CERTIFICATE OF APPROPRIATENESS

Property: 412 Hawthorne Street, Lot 18, Block 1, Westmoreland Subdivision. The property includes a historic two-story wood frame 2,539 square foot single-family residence situated on a 5,871 square foot interior lot.

Proposal: Alteration – Proposed changes to front façade:

RECESSED MOUNTED REPLACEMENT 1-OVER-1 ALUMINUM CLAD SASH WINDOWS

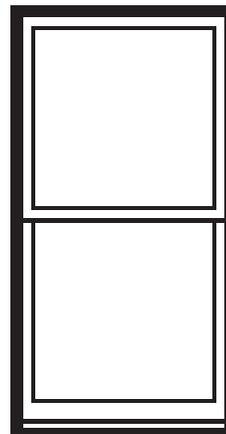
- Approval to replace existing 8 wood 1-over-1 sash windows with 8 aluminum clad 1-over-1 windows.
• Denial to replace the 2 decorative sash windows on the south elevation of the second floor. The windows must be retained and repaired.
• Denial to replace the existing beveled lap siding with either new beveled lap siding or cementitious beveled laps siding. The existing original beveled lap siding is in good condition and must be retained and repaired. Where the siding is damaged or deteriorated past point of repair, new wood beveled lap siding can be patched in. Before any siding is removed and replaced, it must be inspected by HPO Staff.

- Approval to replace existing 8 wood 1-over-1 sash windows with 8 aluminum clad 1-over-1 windows.
• 2 decorative sash windows on the south elevation of the second floor to be retained and repaired.
• Existing original beveled lap siding in good condition must be retained and repaired. Where the siding is damaged or deteriorated past point of repair, new wood beveled lap siding can be patched in. Before any siding is removed and replaced, it must be inspected by HPO Staff

REPLACEMENT DECORATIVE ALUMINUM CLAD SASH WINDOWS

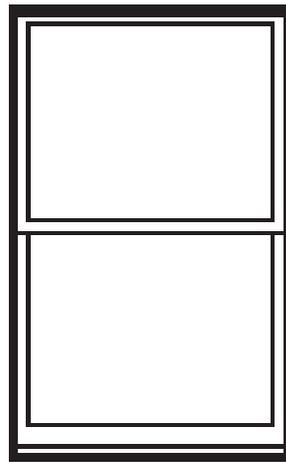
<i>The proposed replacement of the existing original siding and the two decorative sash windows will result in the loss of a large amount of original historic material. The siding and decorative windows were inspected by Staff and the Senior Structural Inspector, it was determined that the siding and decorative sash windows are in good condition and should be retained and repaired.</i> |
